Access Compliance Report

Public Rights-of-Way

(Curb Ramps)

Intersection ID: 10041752	Main Street: WILKINSON_BV	Cross Street: N/A	Location: NE
ADA ID: 0C024458430B	Ramp Type: Perp	Initial Pass/Fail: Fail	Overall Compliance: No
Severity Score: 10			
Codes/Mitigation Info/Possible Solution		Field Measurements/Component Compliance

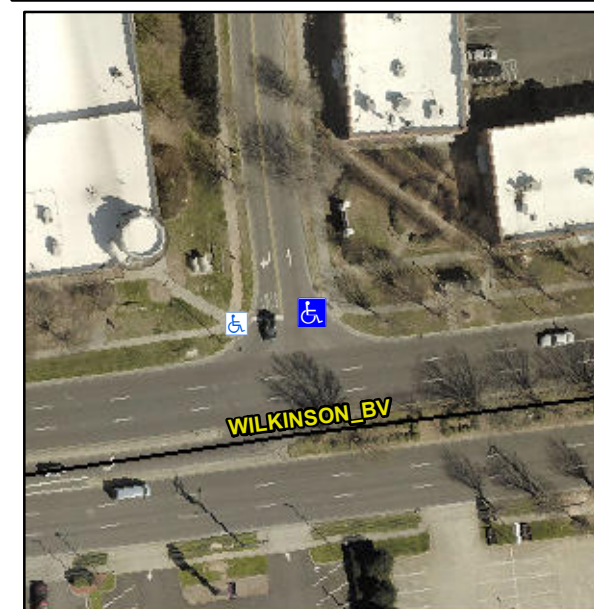
Not Found, R304.5.1, R304.5.3

Compliance	Description	Data	Compliance	Description	Data
N/A	Ramp Length (in)	55.0	Yes	Ramp Slope (%)	7.3
No	Ramp Width (in)	47.0	No	Ramp XSlope (%)	2.2
N/A	Flare Type LT	N/A	N/A	Flare Type RT	N/A
N/A	Flare Slope LT (%)	N/A	N/A	Flare Slope RT (%)	N/A
N/A	Flare Traversable LT?	N/A	N/A	Flare Traversable RT?	N/A
N/A	Landing Length (in)	N/A	N/A	DWS Provided?	N/A
N/A	Landing Width (in)	N/A	N/A	DWS Contrast?	N/A
N/A	Landing Slope (%)	N/A	N/A	DWS Length (in)	N/A
N/A	Landing X Slope (%)	N/A	N/A	DWS Full Width?	N/A
N/A	Landing Curb? (Y/N)	N/A	N/A	DWS Offset (in)	N/A
N/A	Shared Landing?	N/A			
N/A	Gutter Ponding?	N/A	N/A	Gutter Slope (%)	N/A
N/A	Gutter Lip Ht (in)	N/A	N/A	Gutter X Slope (%)	N/A
N/A	Painted X Walk1?	No	N/A	Painted X Walk2?	N/A
	X Walk 1 Direction	To W		X Walk 2 Direction	N/A
N/A	X Walk 1 Width (in)	N/A	N/A	X Walk 2 Width (in)	N/A
	X Walk 1 Slope (%)	3.8		X Walk 2 Slope (%)	N/A
	X Walk 1 X Slope (%)	1.2		X Walk 2 X Slope (%)	N/A

Remove & Replace Entire Ramp.
